Subject: UniStar Nuclear Energy, NRC Docket No. 52-016  
Response to Request for Additional Information for the  
Calvert Cliffs Nuclear Power Plant, Unit 3,  
RAI No. 99, Probable Maximum Tsunami Flooding, Questions 02.04.06-10,  
02.04.06-12 through 02.04.06-17

**Response to NRC Request for Additional Information RAI No. 99,  
Question 02.04.06-10, 02.04.06-12 through 02.04.06-17,  
Probable Maximum Tsunami Flooding, Calvert Cliffs Nuclear Power Plant, Unit 3**

**RAI No. 99**

Figure 1. Contour of Maximum Tsunami Amplitude for Case 1 with Nonlinear Simulation Option

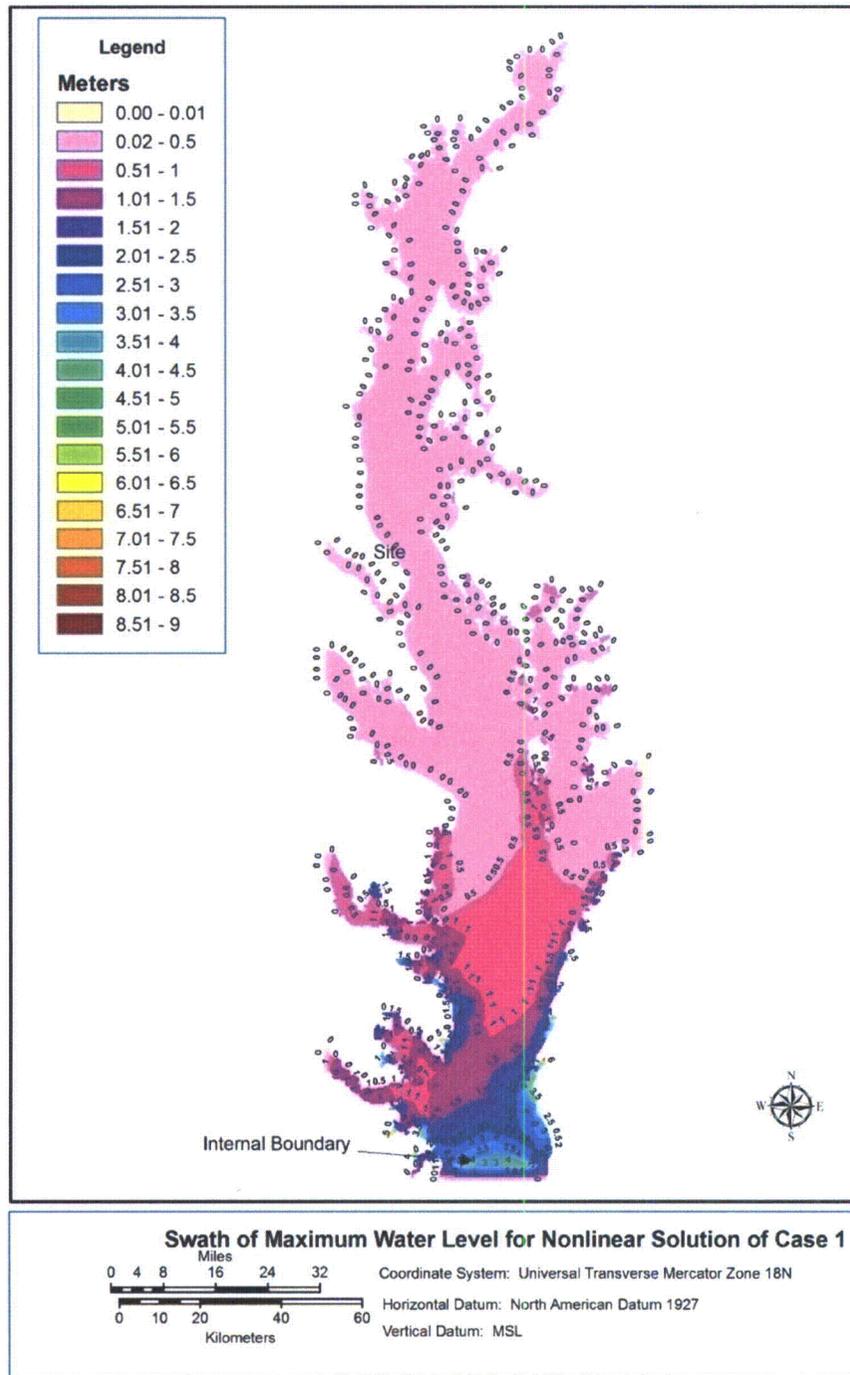
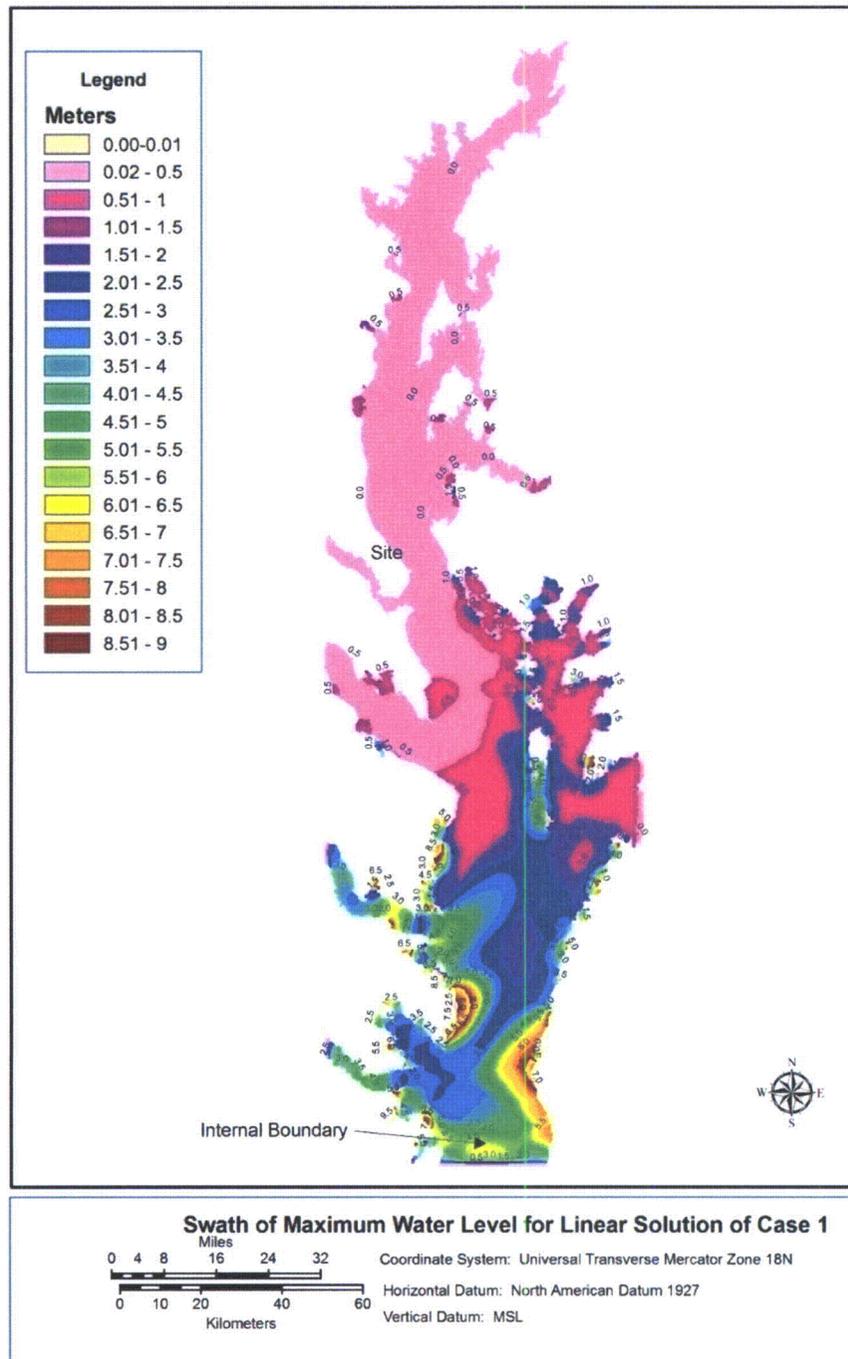
Section C.I.2.4.6.4 of Regulatory Guide 1.206 (RG 1.206) provides specific guidance with respect to tsunami analysis. This includes providing a complete description of the analysis procedure used to calculate tsunami wave height and period at the site. Clarify the phrase "waves quickly dispersed" in the updated FSAR and provide a surface contour map of maximum tsunami wave height in Chesapeake Bay.

Tsunami propagation in the Chesapeake Bay was simulated using both linear (TSU) and nonlinear (NLSWE) models. Three tsunami sources were considered, representing local and distant tsunami generators. The resultant tsunami waves entering the bay were applied at an internal model boundary near the mouth of the bay and propagated in the bay towards Calvert Cliffs Nuclear Power Plant (CCNPP) Unit 3 by model simulation. Model results show that the waves entering the bay would undergo significant dissipation as they reached the CCNPP Unit 3 site, which is approximately 90 mi (145 km) inside the bay from the model boundary. For the Case 1 nonlinear simulation, the 4 m (13.1 ft) tsunami amplitude entering the bay was reduced in magnitude to about 0.155 m (0.51 ft) at the site, a 96 percent reduction in amplitude. For the Case 1 linear simulation, the tsunami amplitude was reduced in magnitude to 0.326 m (1.07 ft), a 92 percent reduction in amplitude. Figures 1 and 2 represent contour maps of maximum tsunami wave height in the bay for the Case 1 nonlinear and linear simulations, respectively. As shown in these results, most tsunami amplitude dissipation occurs within about the first 50 mi (80 km) of the boundary. This occurs because the bay is relatively shallow. These results provide the basis of the phrase "waves quickly dispersed" that is included in the FSAR.

Figure 1: 30-m Square Grid DEM from NOAA National Ocean Service

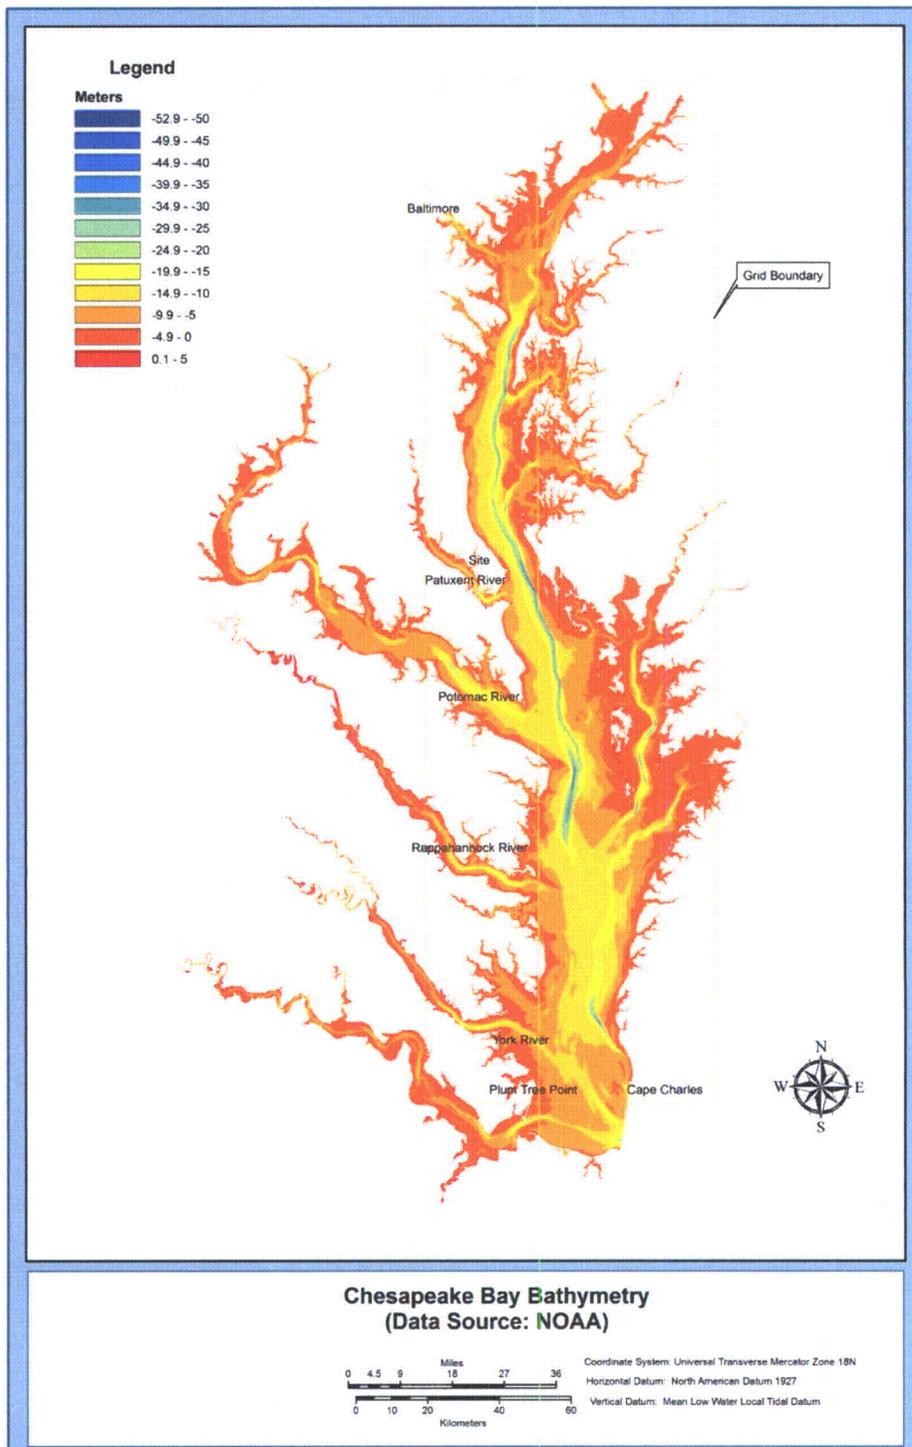
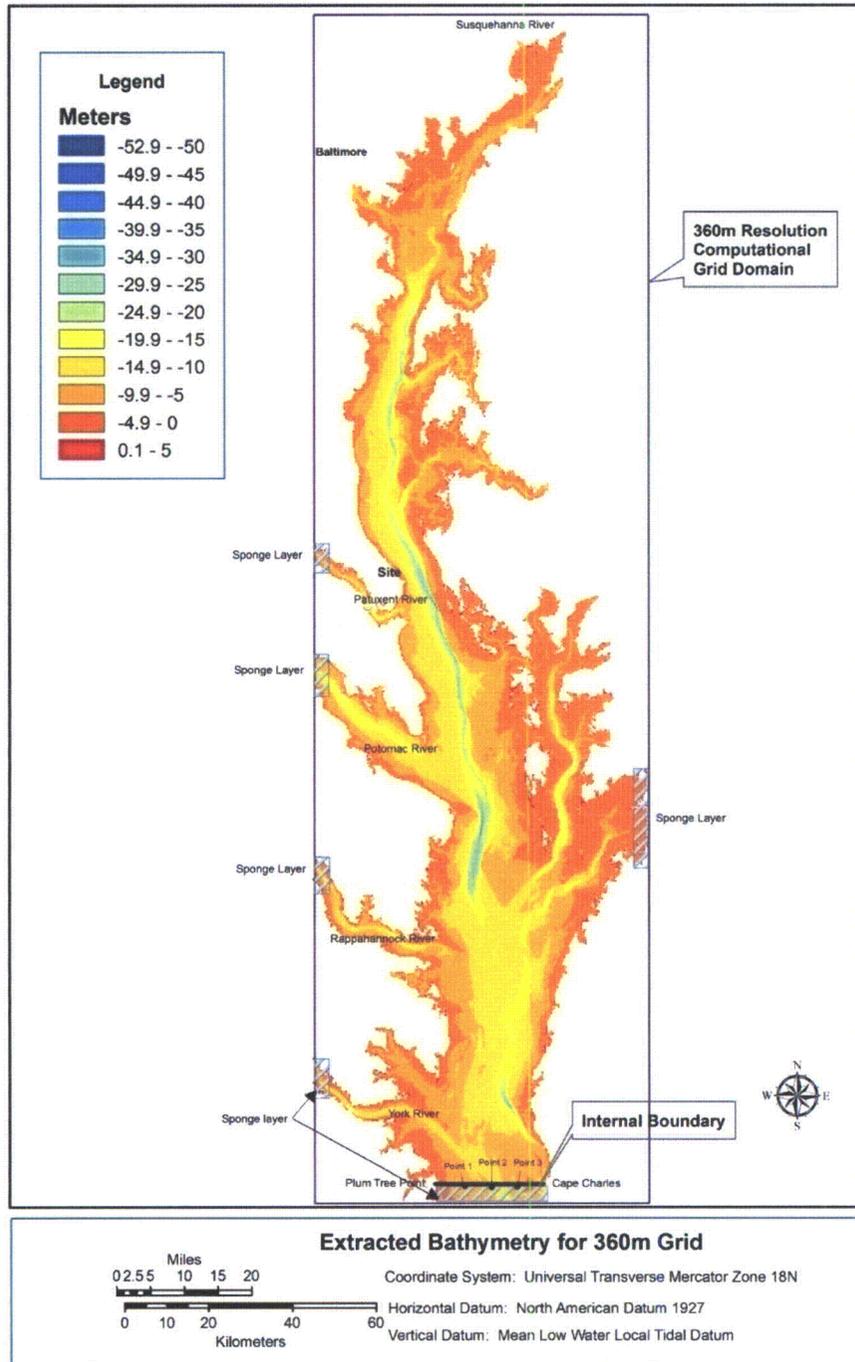
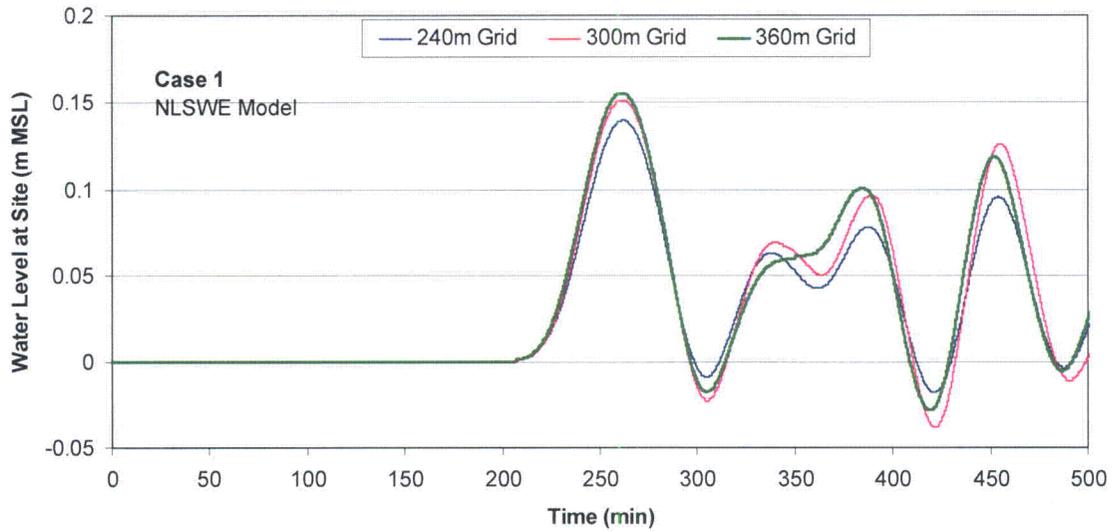
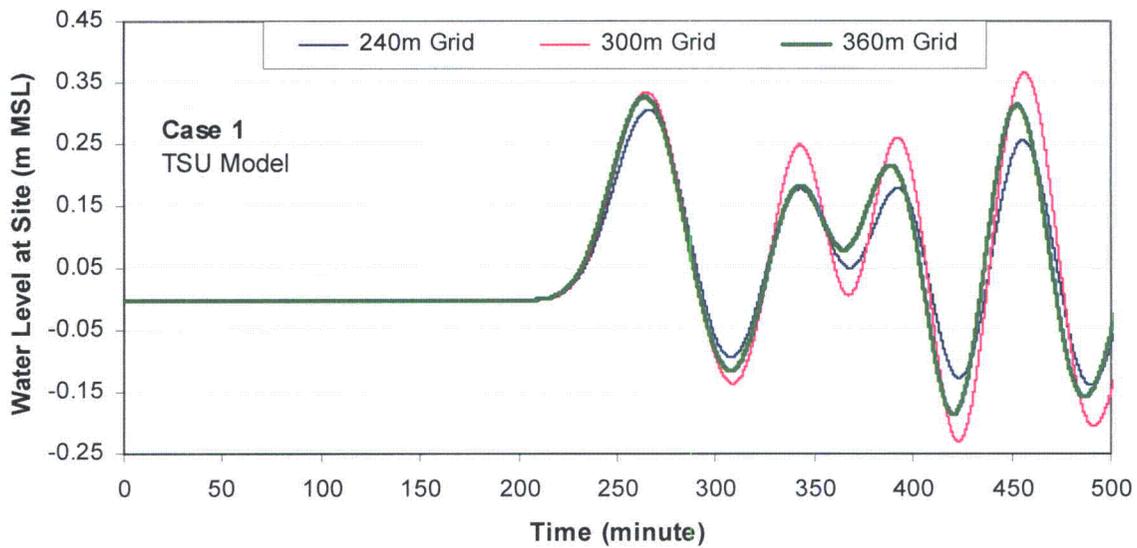
Section C.I.2.4.6.4 of Regulatory Guide 1.206 (RG 1.206) provides specific guidance with respect to tsunami analysis. This includes providing a complete description of the analysis procedure used to calculate tsunami wave height and period at the site. Describe the source of data and method used to develop the bathymetric grid for the tsunami model. Also provide a description of the grid-size sensitivity test in the updated FSAR.

The grid size for the Chesapeake Bay model bathymetry was selected based on the consideration that tsunami wavelengths include sufficient number of grid points, as described in Section 2.4.6.4.1 of the CCNPP Unit 3 FSAR. The selected 360 m square grid spacing encompasses about 92 grid points for one wavelength. Water depths were assigned to each 360 m by 360 m grid cell by sampling the 30 m NOAA DEM data at an appropriate interval. For example, the 360 m grid model bathymetry was developed by sampling every 12<sup>th</sup> data point from the 30 m NOAA DEM data. The original 30 m NOAA bathymetry and 360 m model bathymetry are shown on Figures 1 and 2, respectively.

To assess the sensitivity of model results to grid size, model sensitivity tests with grid sizes of 240 m, 300 m, and 360 m were performed for Case 1 using both nonlinear and linear simulation models. The maximum and minimum water levels produced by different grid sizes are listed in Table 1. Figures 3 and 4 show the simulated water levels at the CCNPP Unit 3 site for nonlinear and linear models, respectively, as a function of grid size. The results indicate that the maximum water level at the site decreases with the reduction of grid size for nonlinear solutions, whereas there is no clear trend for the minimum water level. For the linear solutions, there is no clear trend for the maximum and minimum water levels with the grid size. The 360 m grid produces a slightly lower maximum water level than the 300 m grid, but a higher maximum water level than does the 240 m grid. It can be concluded that grids finer than 360 m do not

**Figure 1. Comparison of Water Level at the Site for Different Cutoff Depths, Nonlinear Model Simulation Option**

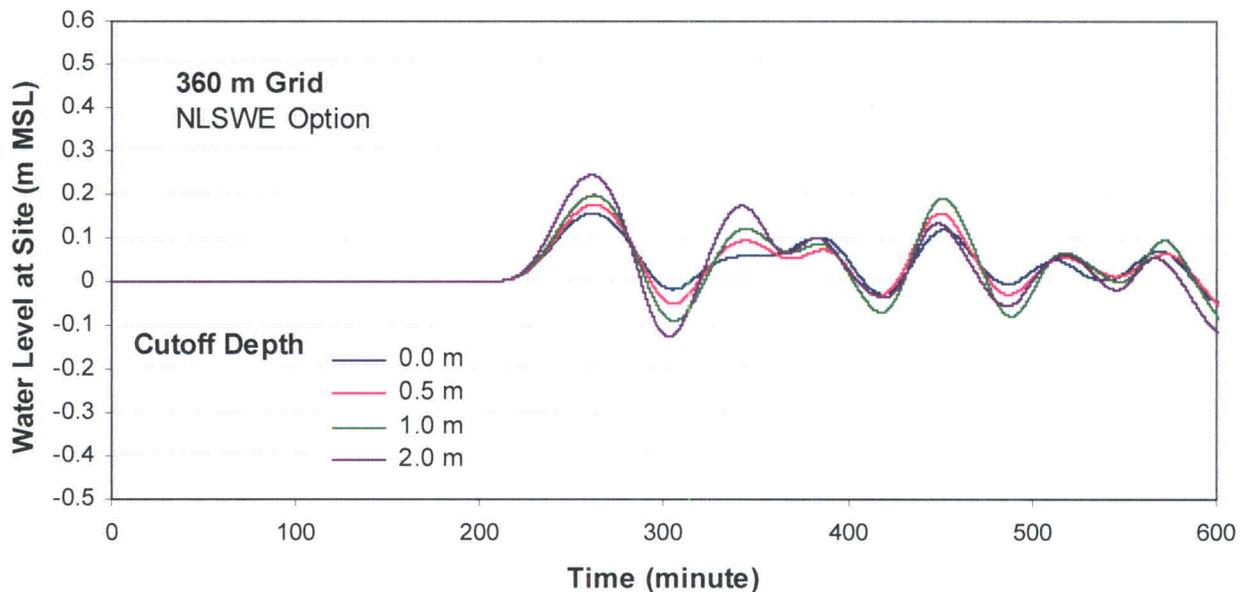
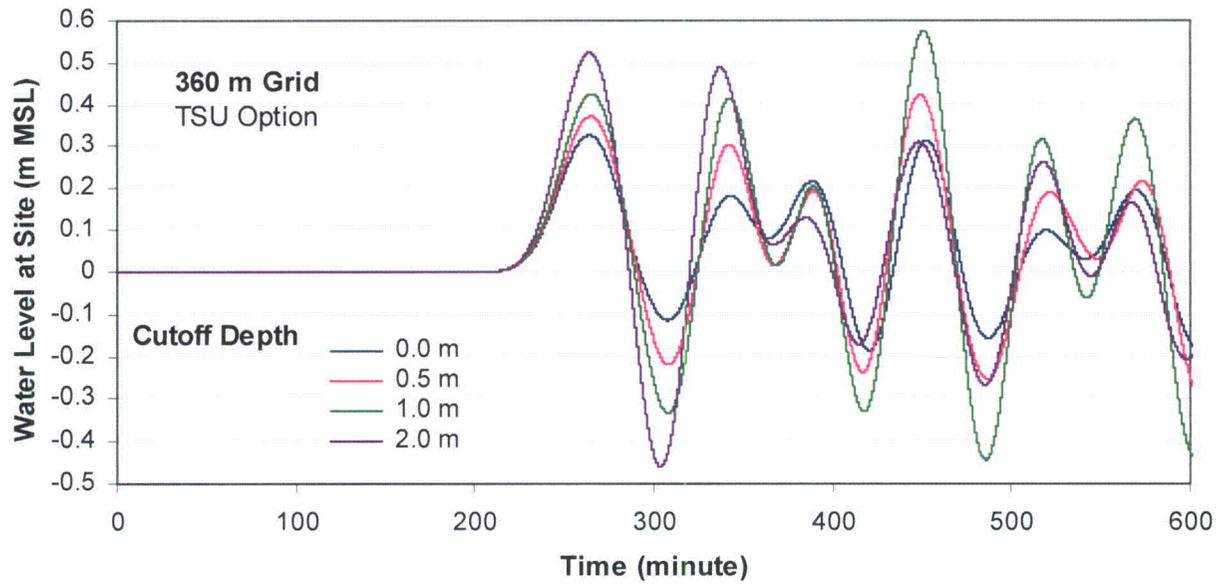
Section C.I.2.4.6.5 of Regulatory Guide 1.206 (RG 1.206) provides specific guidance with respect to tsunami water levels. This includes providing estimates of maximum and minimum (low water) tsunami wave heights from both distant and local generators. Provide a discussion in the updated FSAR of how uncertainty in simulated tsunami water levels was determined.

To quantitatively assess the effects of confining the tsunami computations to grid points where the ratio of tsunami amplitude to water depth is relatively large, a series of model sensitivity simulations were performed wherein the minimum allowable water depth (cutoff depth) was varied in the model. Three simulations with cutoff depths of 0.5 m, 1.0 m, and 2.0 m for both linear and nonlinear models were conducted using the Case 1 tsunami generator. In each simulation, portions of the domain having water depths less than the cutoff depth were eliminated from the model domain. The shallow water areas of the Chesapeake Bay affected by imposing cutoff depths include the western shoreline near the Potomac River mouth and upstream of the CCNPP Unit 3 site. The simulated water levels at the site are shown on Figures 1 and 2. The relative increases in maximum amplitude at the site as a function of cutoff depth are summarized in Table 1.

The results from these simulations show that the amplitudes of the tsunami wave peaks and troughs at the CCNPP Unit 3 site generally increase with increasing cutoff depth for both linear and nonlinear models. Note that the maximum relative increase in amplitude (77 percent) occurred in the linear simulation with a 1.0 m cutoff depth; however, the maximum water level for this simulation appeared during the third wave peak, unlike other cases wherein the relative increase was greatest for the first peak. Excluding this apparently anomalous case, the 2.0 m

cutoff depth resulted in the maximum water level. Consequently, the selected maximum water level from the Case 1 linear simulation was increased by 60 percent to obtain the PMT water level at the Unit 3 site. The same factor was also adopted for the PMT drawdown level.

**Figure 2.4-32—{Computational Domain and Model Bathymetry for Tsunami Simulation in Chesapeake Bay}**

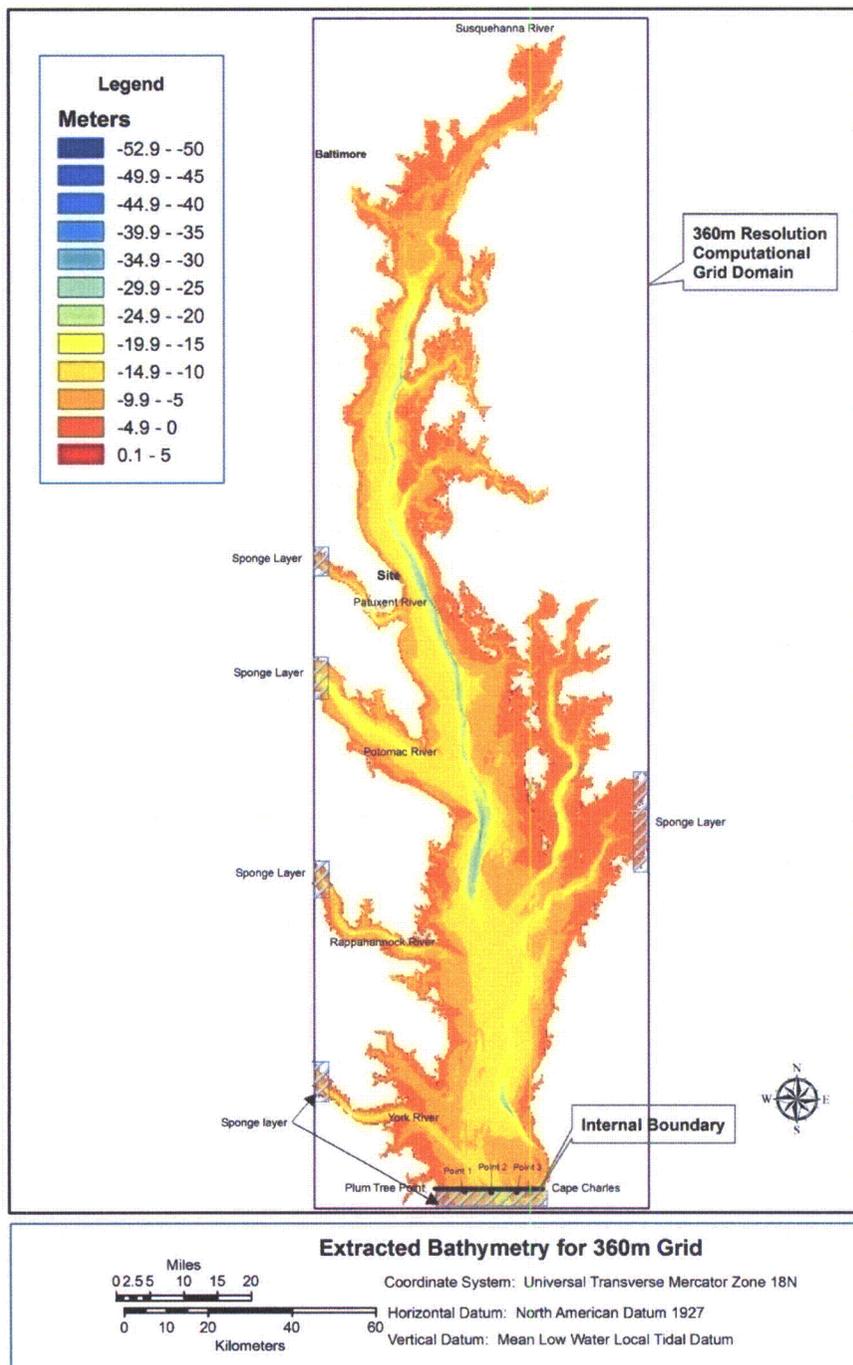
Figure 2.4-32 will be replaced as follows in a future version of the COLA. For clarity, only the revised figure is shown.

by 360 m was adopted for the computational domain. The numbers of grids in the two horizontal directions are 223 (east-west direction) and 790 (north-south direction). The bathymetric data used in the model, based on the 360 m by 360 m grid, are shown in Figure 2.4-32.

**Figure 2.4-37—{Time History of Tsunami Water Levels At The Site, Case 1 through 3, Nonlinear Model}**

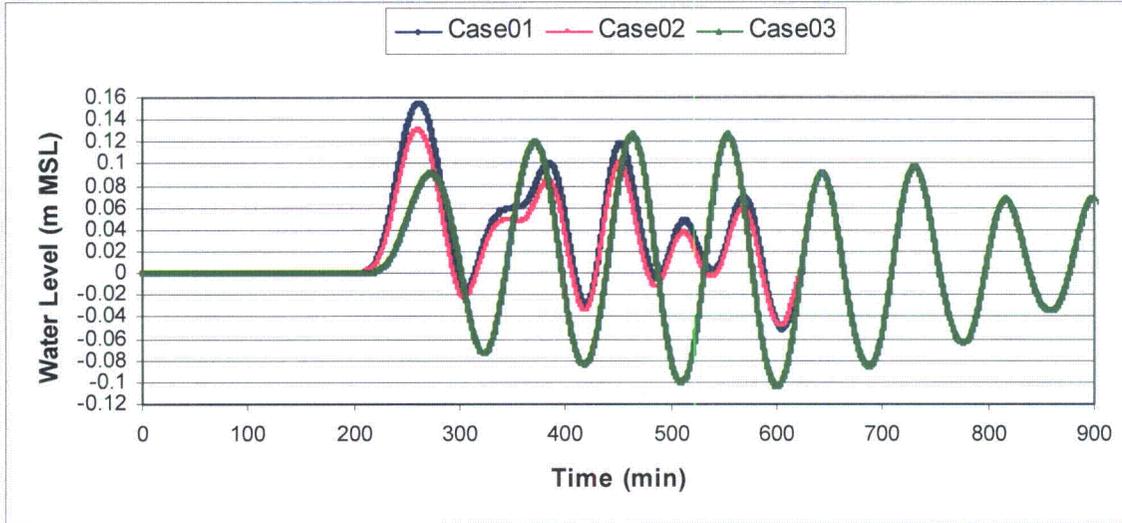
Figure 2.4-37 will be replaced as follows in a future version of the COLA. For clarity, only the revised figure is shown.

Variations in simulated water levels with time at the CCNPP Unit 3 site for the selected tsunami scenarios are shown in Figure 2.4-37 and Figure 2.4-38. These results show that the maximum tsunami amplitude at the CCNPP Unit 3 site is associated with Case 1, the Norfolk Canyon submarine landslide scenario, while the maximum tsunami drawdown that would occur is associated with Case 3, the Haitian earthquake scenario. Both maximum tsunami amplitude and drawdown were obtained with the linear (TSU) model. As shown in Table 2.4-28, the maximum tsunami amplitude and drawdown elevations at the CCNPP Unit 3 site are 1.07 ft (0.326 m) and 0.78 ft (0.237 m), respectively, as referenced to MSL. The results indicate that the linear solution of the shallow water equations provides bounding estimates of tsunami amplitude and drawdown at the CCNPP Unit 3 site.
